NUCLEAR REGULATORY COMMISSION

Title: Advisory Committee on Reactor Safeguards
ESBWR Subcommittee: North Anna COLA

Date: Friday, August 21, 2009

MEETING OF THE ESBWR SUBCOMMITTEE ON THE NORTH ANNA COMBINED LICENSING APPLICATION (COLA)

Based on FSAR Figure 2.4-201

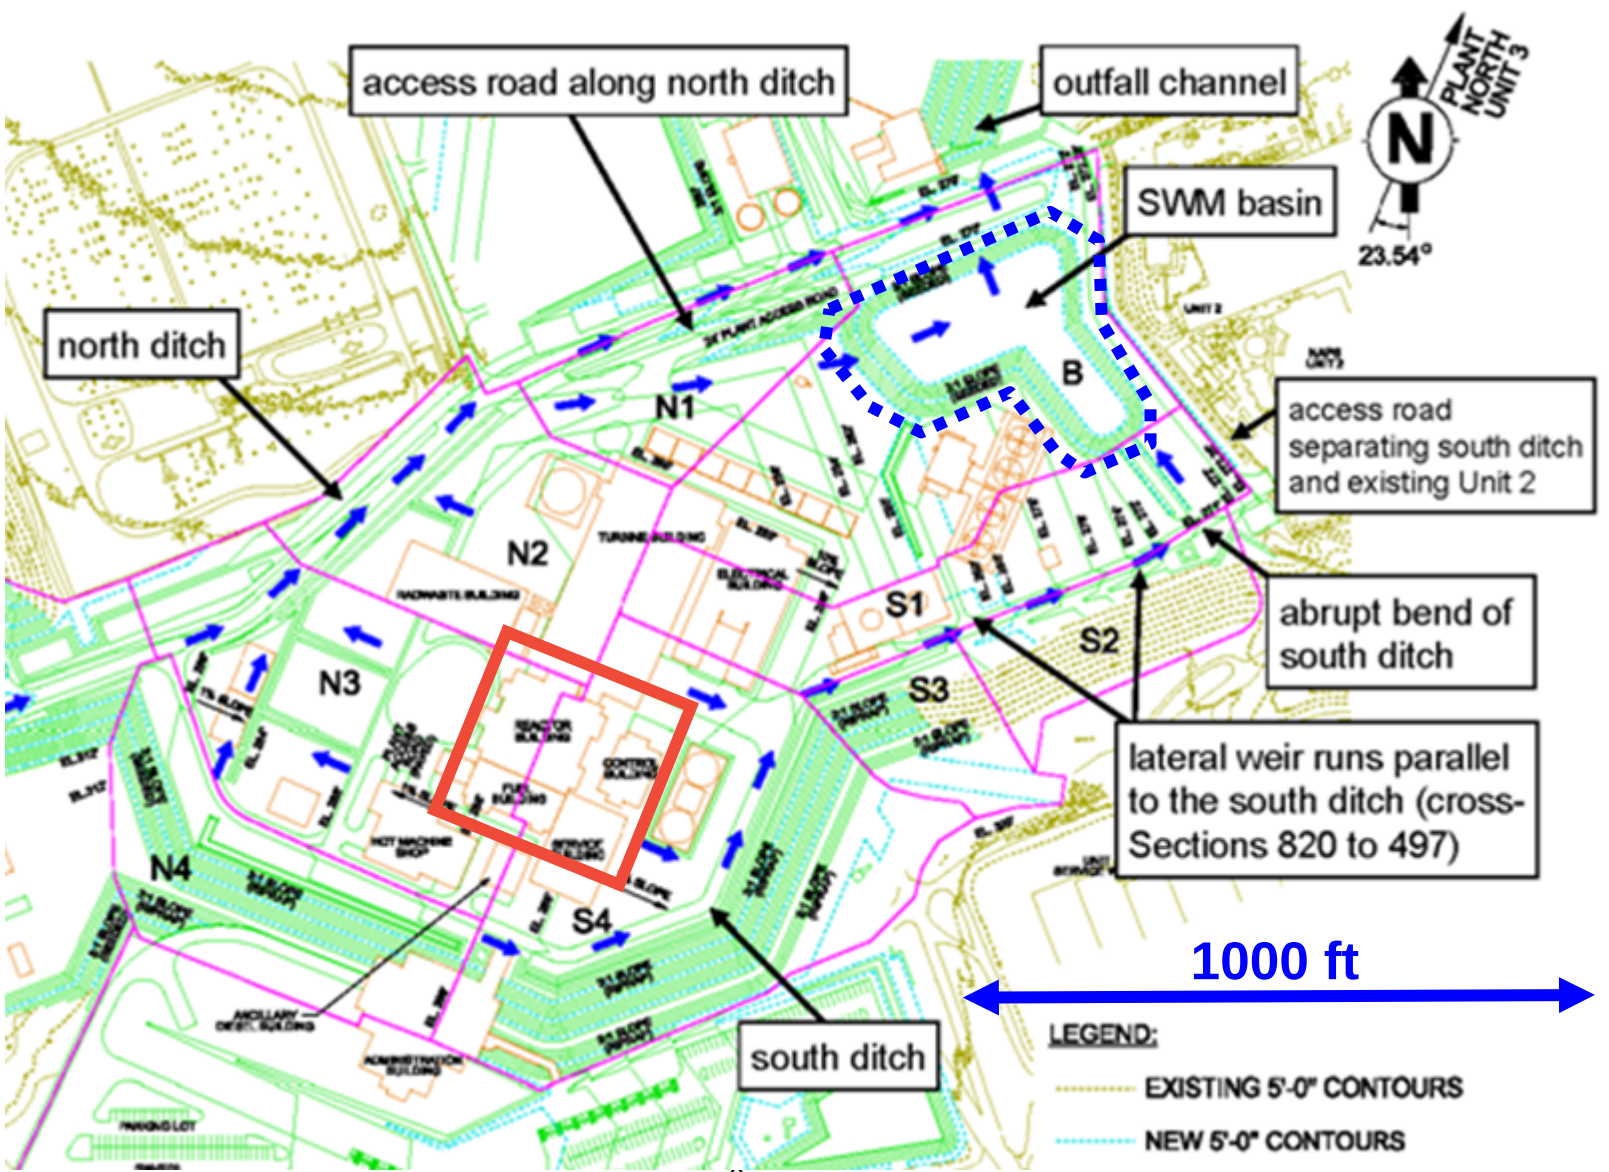
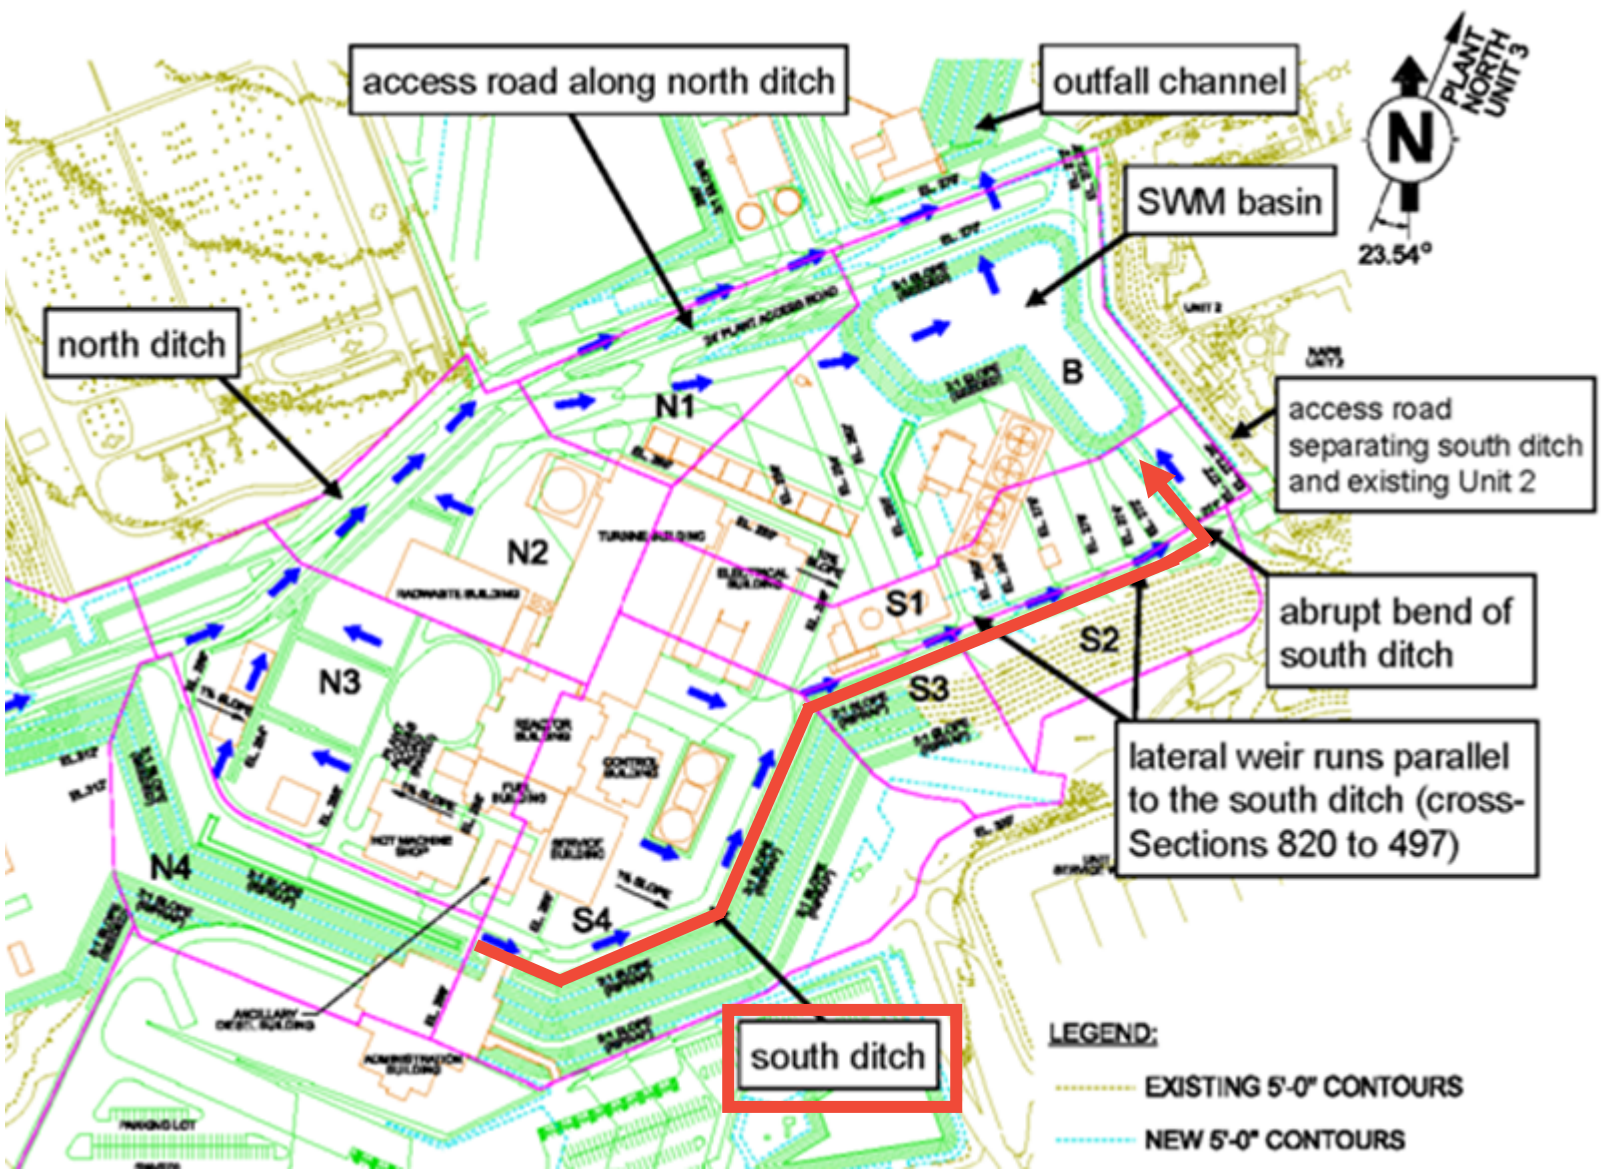
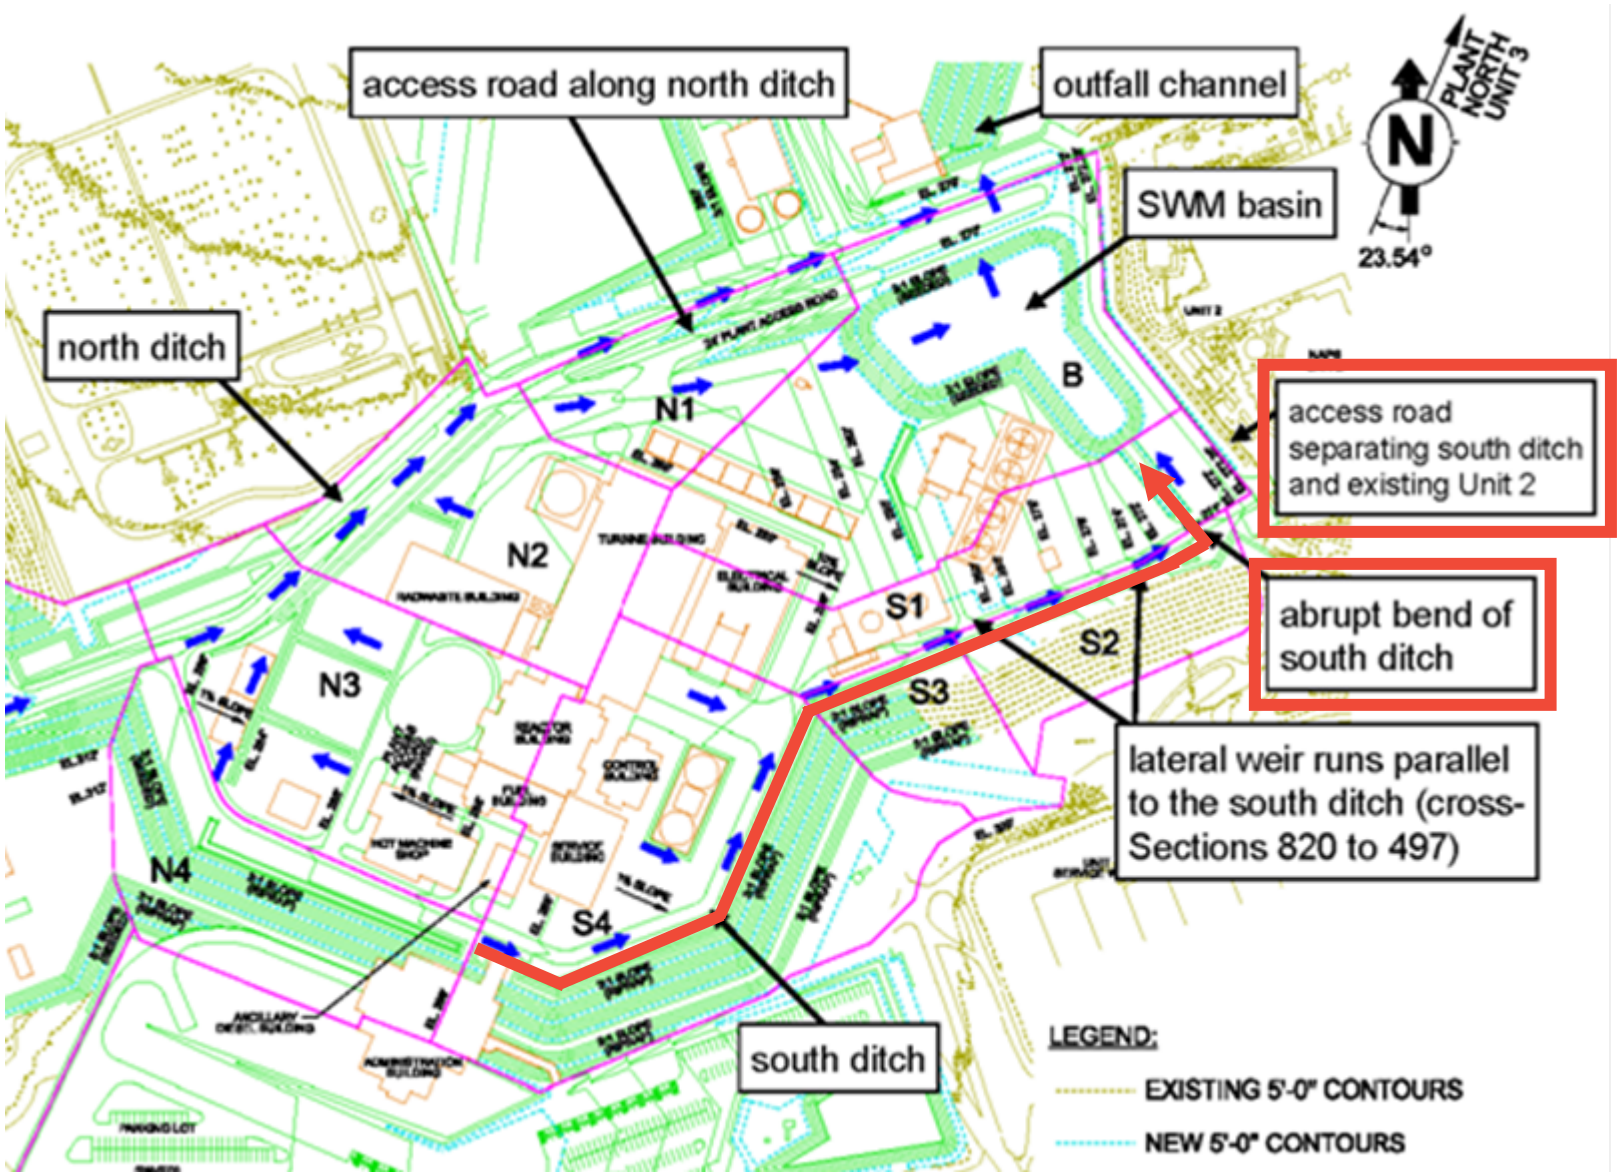
- **Locally Intense Precipitation Flooding**
  - **NAPS ESP COL 2.4-4 (Grading) and 2.4-5 (Elevations of safety-related structures)**
    - Applicant provided HEC-RAS input files for analysis of the locally intense PMP and associated site drainage.
    - NRC staff reviewed HEC-RAS model and conducted sensitivity analyses

Staff Stability of Slopes Confirmatory Analysis

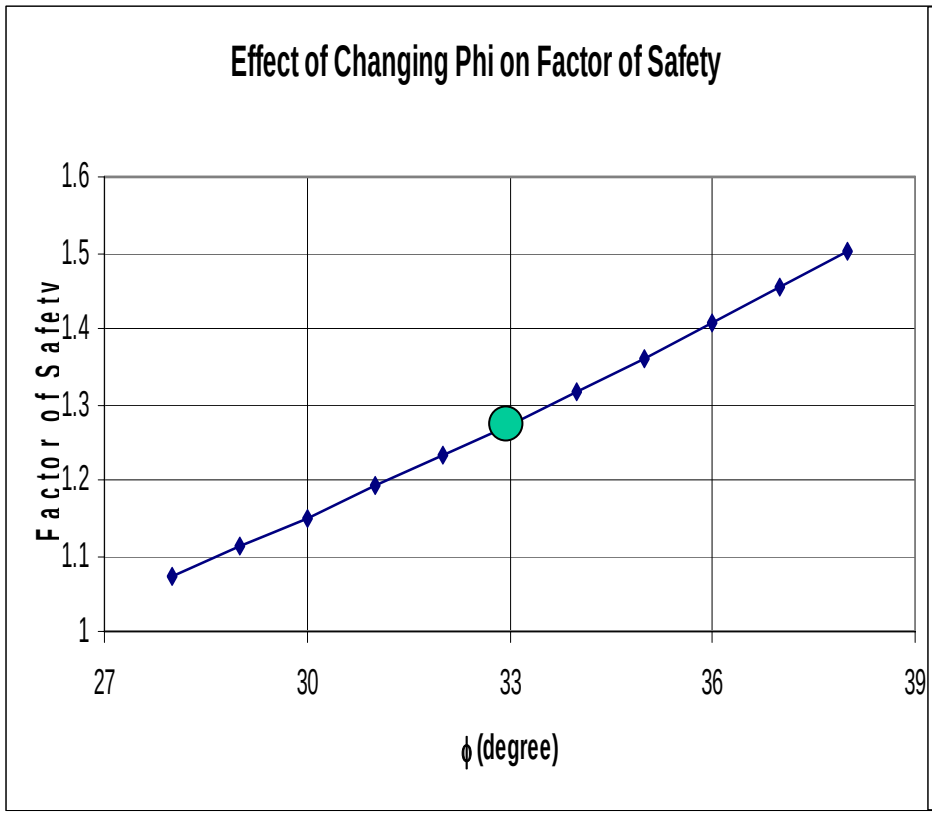
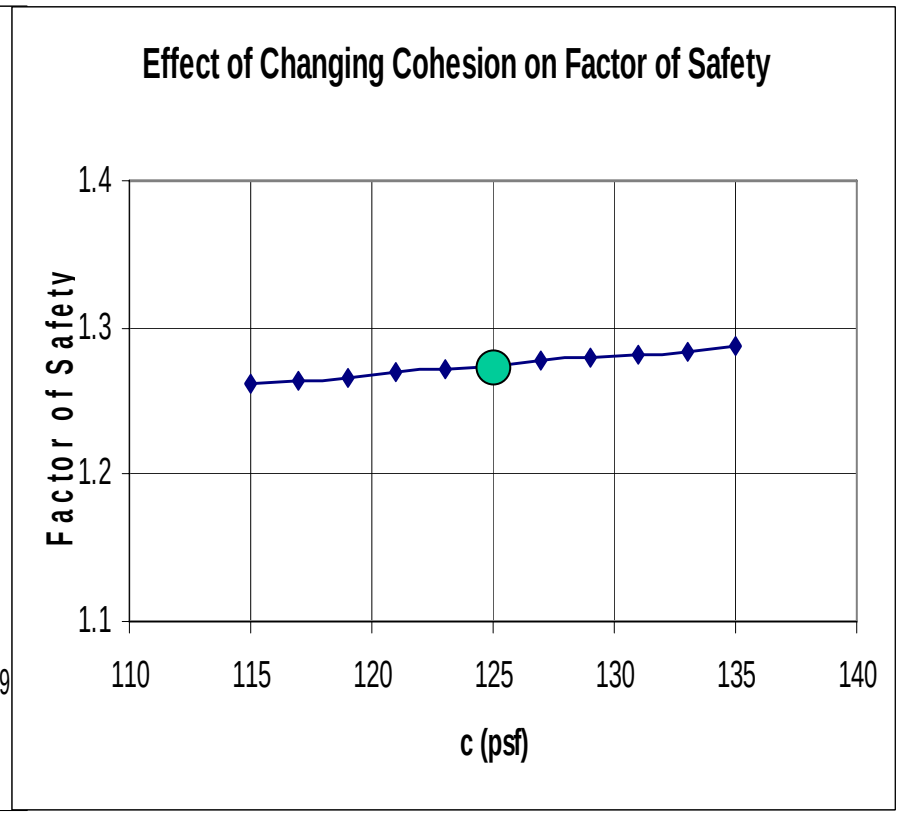
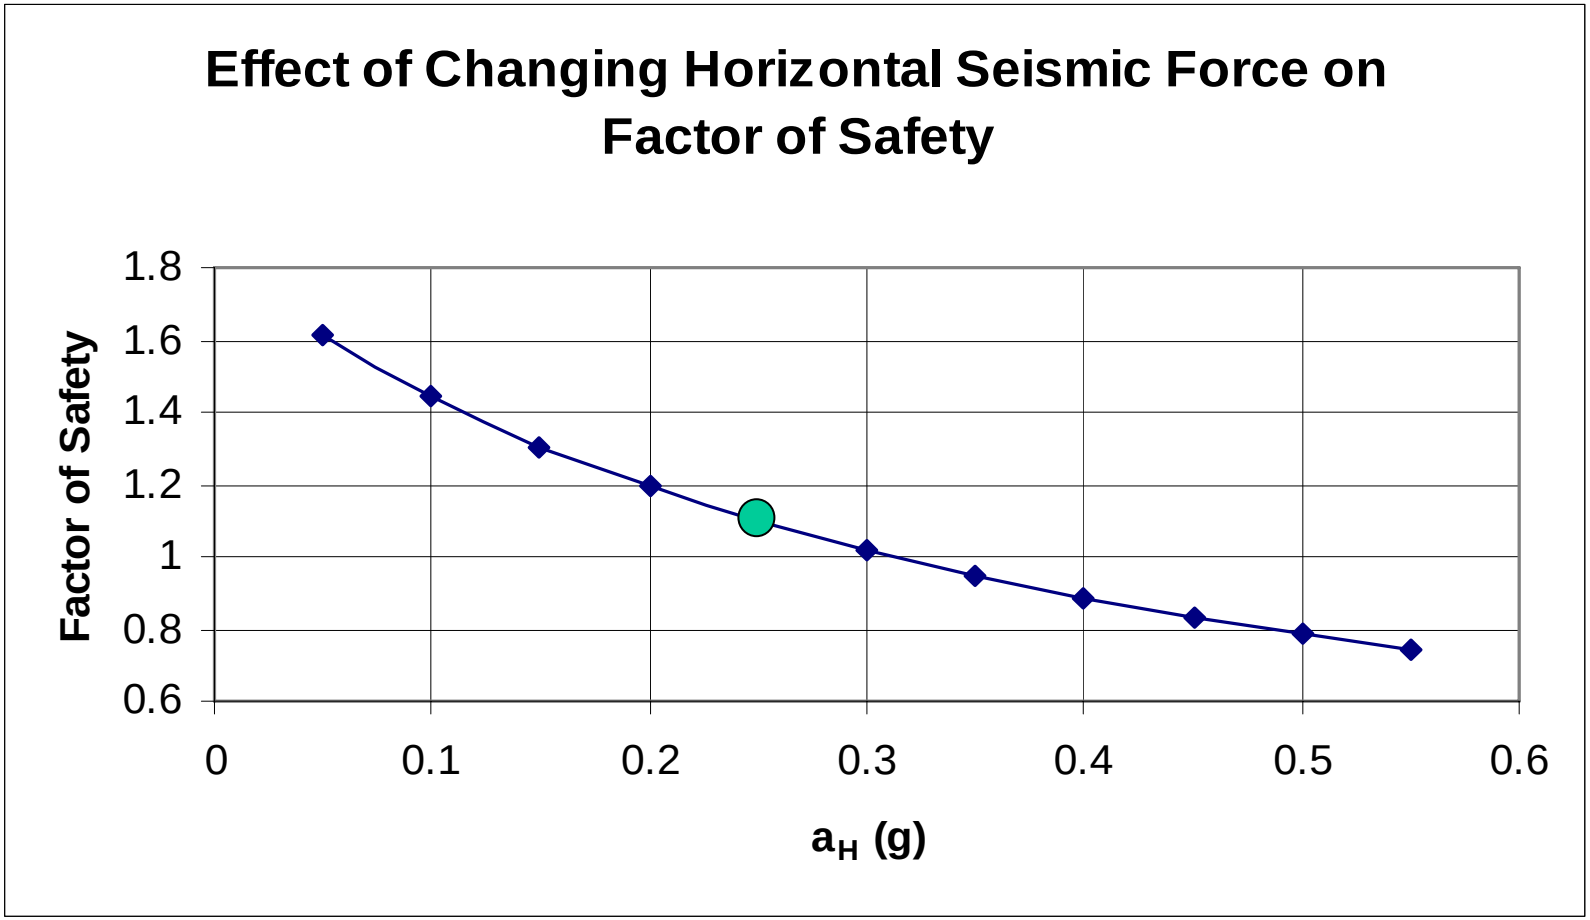
● Applicant used value

Horizontal CSDRS & Unit 3 FIRS for RB/FB and CB (3.7 backup slide 1)

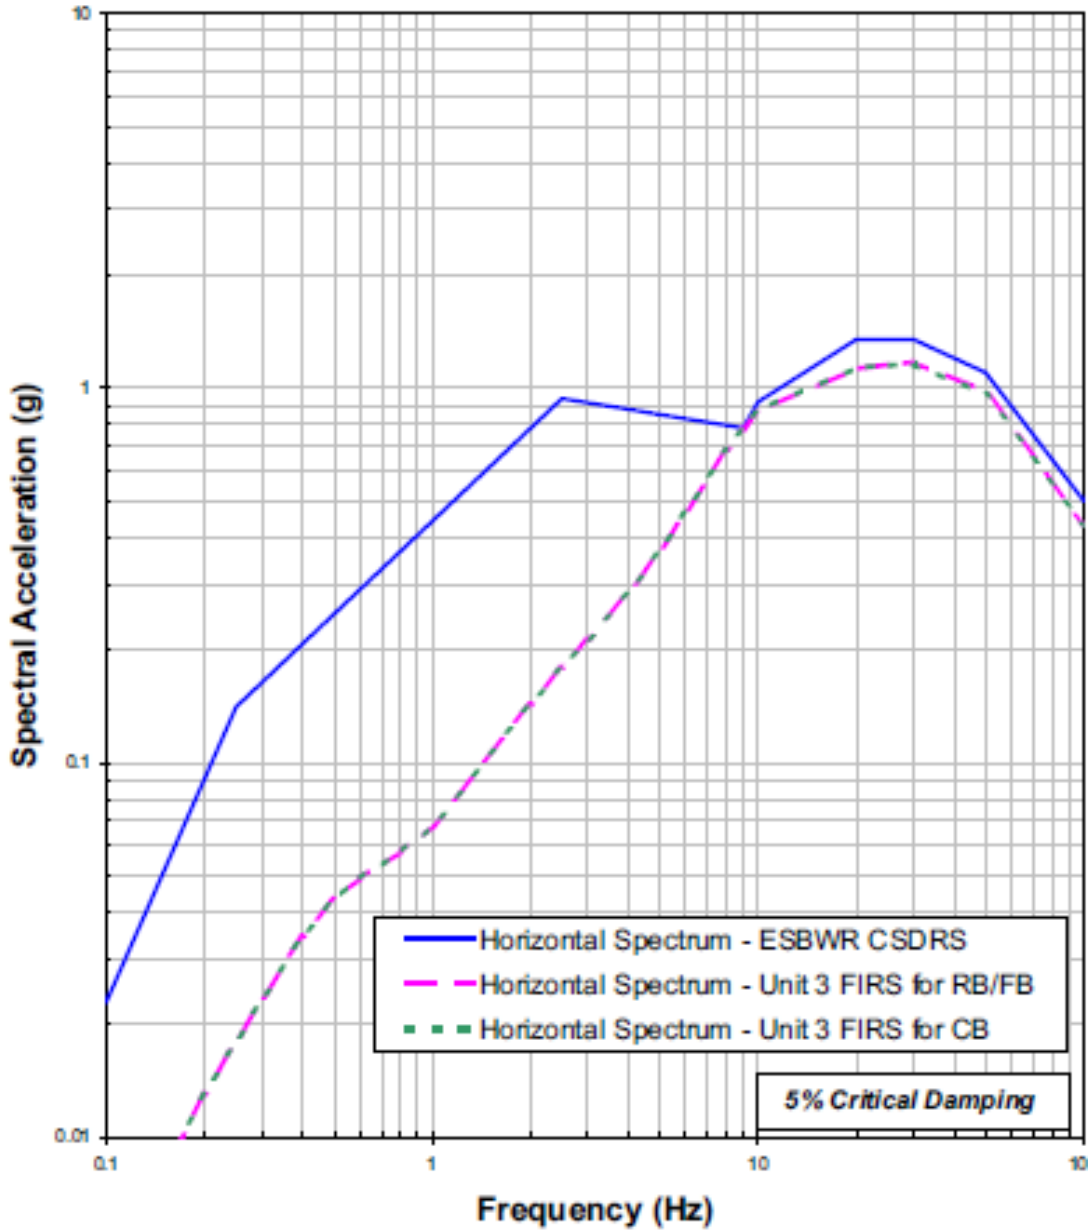
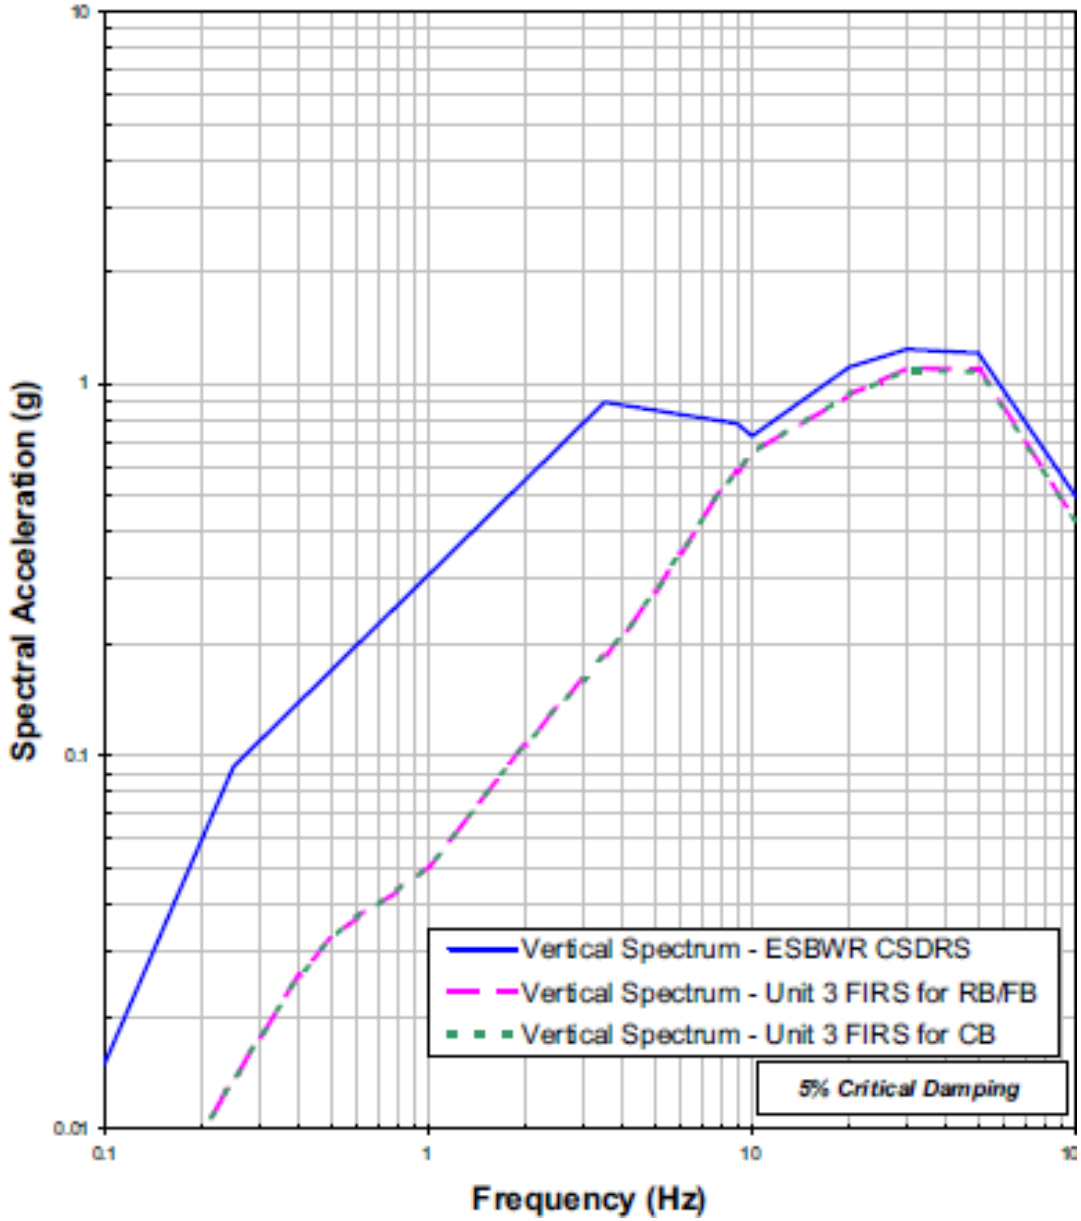
MR. CHAKRAVORTY: My conclusion was that ESBRW SSC spectra, which is generally termed as CSDRS, which means 35 seismic design response spectra, they're developed by enveloping Reg. Guide 160 spectra incurred at .3 G level and also at three site specific response spectra. So these things both.

And the result was that site specific design parameters for reactor building and fuel building and control building that fall within the range of parameters considered in the DCD and the corresponding foundation input response spectra are bounded by the CSDRS site certified design spectra.
